Southern California Edison

A.19-07-015 – TLRR IC

DATA REQUEST SET E D - S C E - 2 4

Proposed Engineering Options
for Crater Mountain Alternative

Detail of Revised Crater Mountain Alternative – to Avoid the WSA

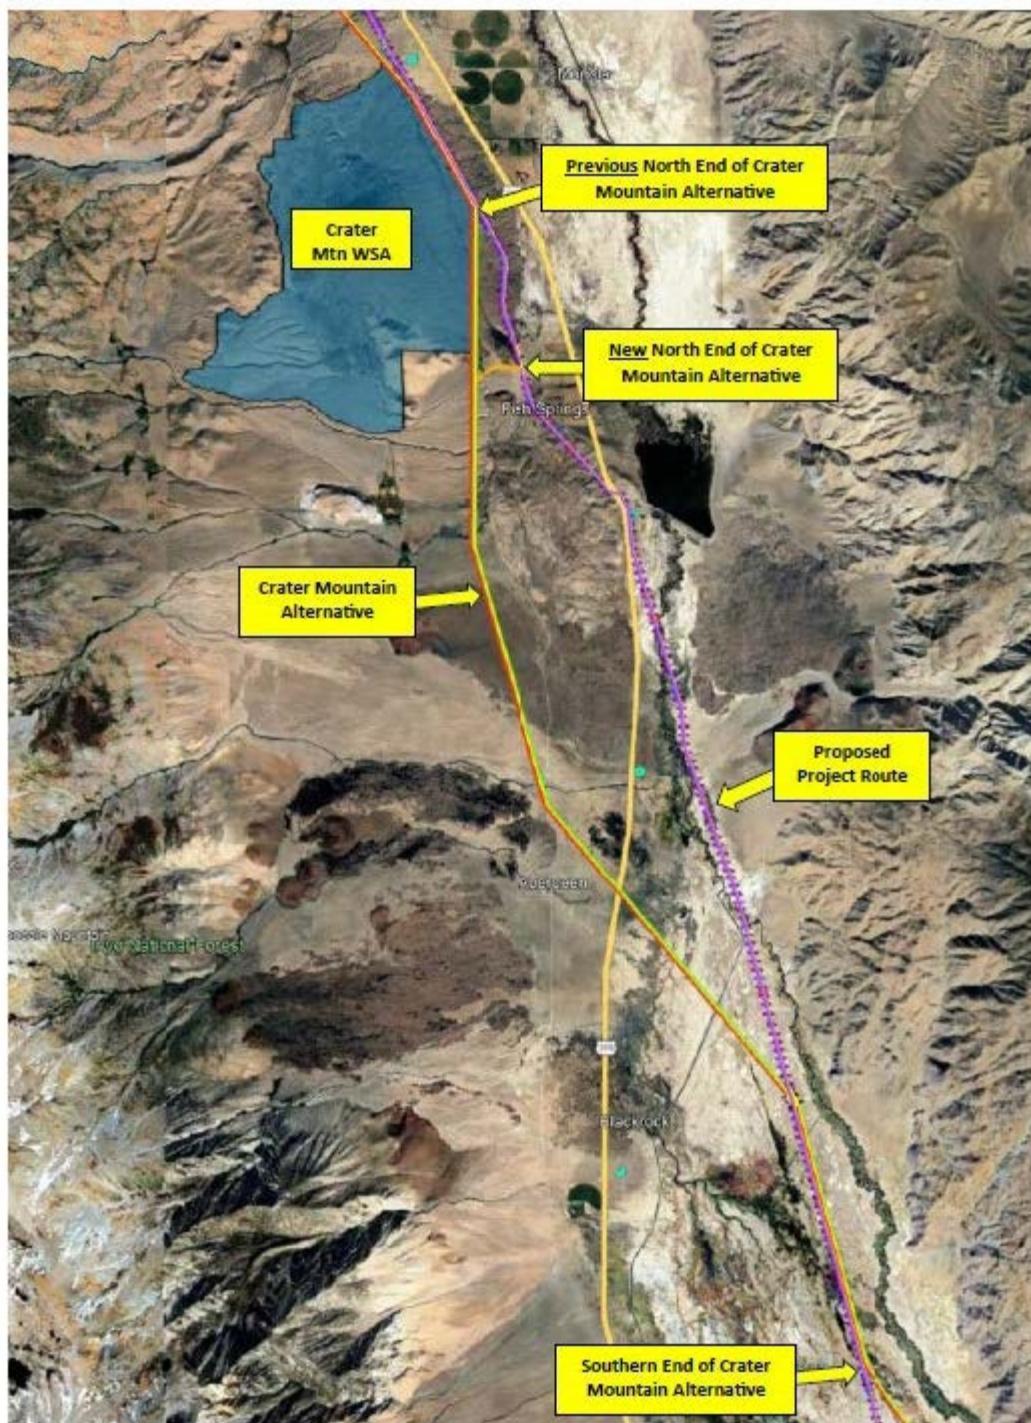
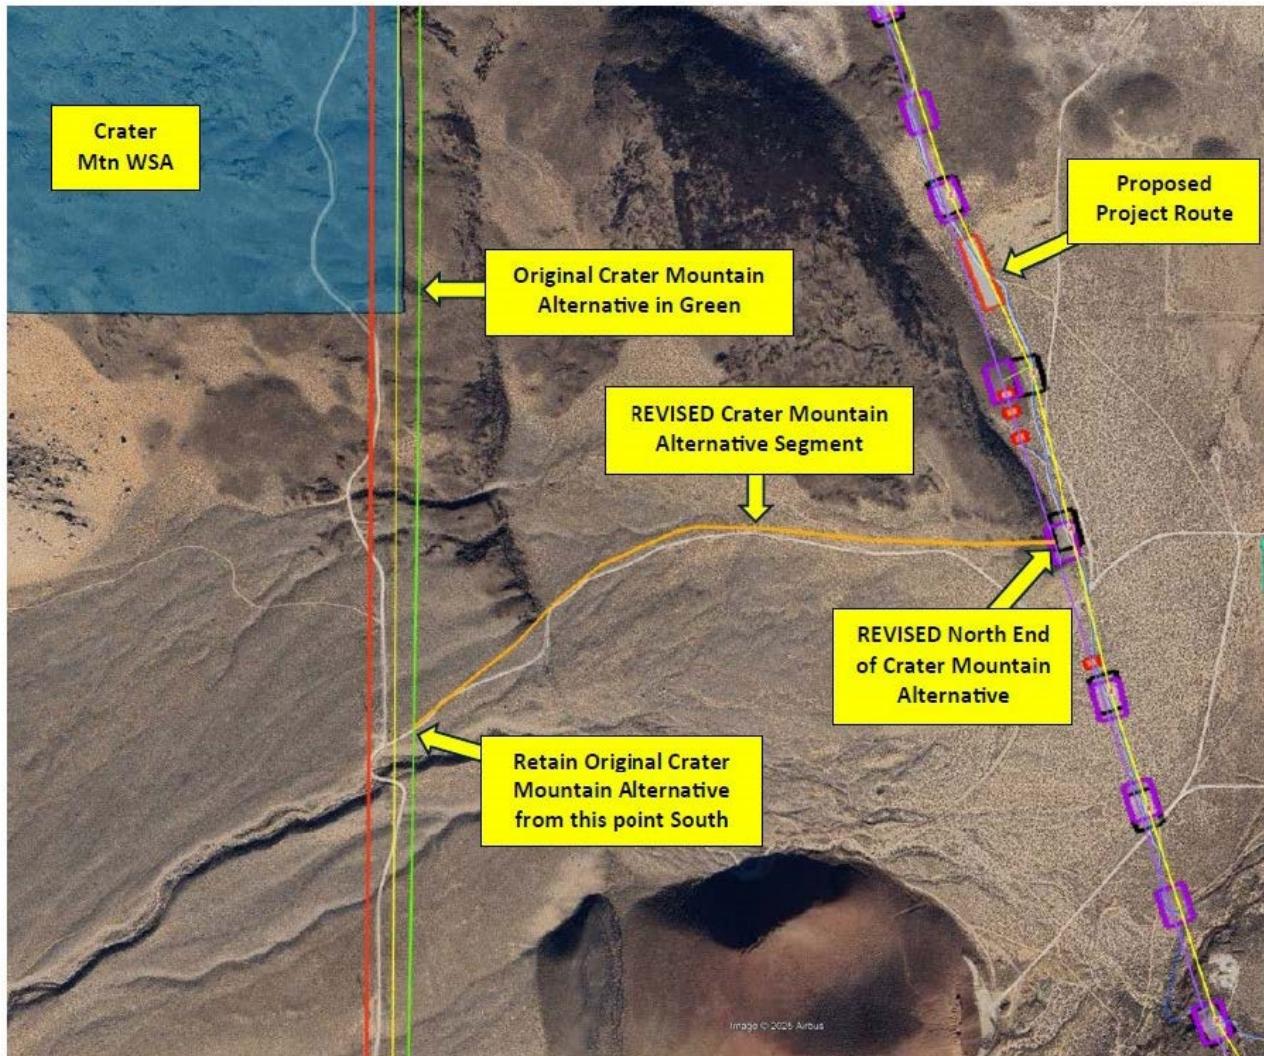
The BLM has identified that a portion of the Crater Mountain Alternative and/or its access road would be within the Crater Mountain Wilderness Study Area (WSA), which is not permittable. We have identified a potential revision to the alternative that would avoid the WSA. It appears that the two parcels that would be crossed by the revised alternative segment are owned by LADWP. Please see Attachment A to this letter. This revision would:

-Retain the southernmost 15.6 miles (of the original 18 miles) of the alternative. The southern endpoint is at approximately Structure 279 (this is also the northern end of the Manzanar Alternative).

-Eliminate the northernmost 2.4 miles of the Crater Mountain Alternative (the part that would be adjacent to or within the WSA), and reconnect with the Existing/Proposed route south of the WSA at Proposed Structure 190. This connection would require a new ROW of approximately 0.7 miles (4-5 structures) along an existing LADWP access road and entirely on LADWP land.

1. Please review this revised alternative and let us know if it would be feasible from an engineering and land ownership perspective.
2. Both the Proposed Project and the current Crater Mountain Alternative have been surveyed for biological and cultural resources with some buffer around each right-of-way. Please let us know how much of this short stretch of new ROW is not covered by completed surveys.

4 or 5 new structures to be located along the existing LADWP access road (orange line below)

SCE developed a preliminary design for the portion of the “Crater Mountain re-route” alternative described in this data request. Please see the attached updated design details, including GIS and

kmz files, which show the proposed structure locations for this new alternative. SCE's analysis concluded that the "Crater Mountain re-route" alternative described in this data request is feasible from both an engineering and land ownership perspective.

The "Crater Mountain re-route" alternative would cross two parcels owned by the Los Angeles Department of Water and Power (LADWP), which are also crossed by the original Crater Mountain Alternative route and the Proposed Project. While SCE has not yet initiated negotiations with LADWP regarding acquisition of land rights in this area, the process for obtaining land rights associated with the "Crater Mountain re-route" alternative described in this data request would follow the same process for acquiring land rights for the balance of the original Crater Mountain Alternative; as such, SCE expects that the land acquisition efforts for this new alternative would be similar in nature.

Approximately 2,000 linear feet of the "Crater Mountain re-route" alternative described in this data request was not surveyed for biological or cultural resources.
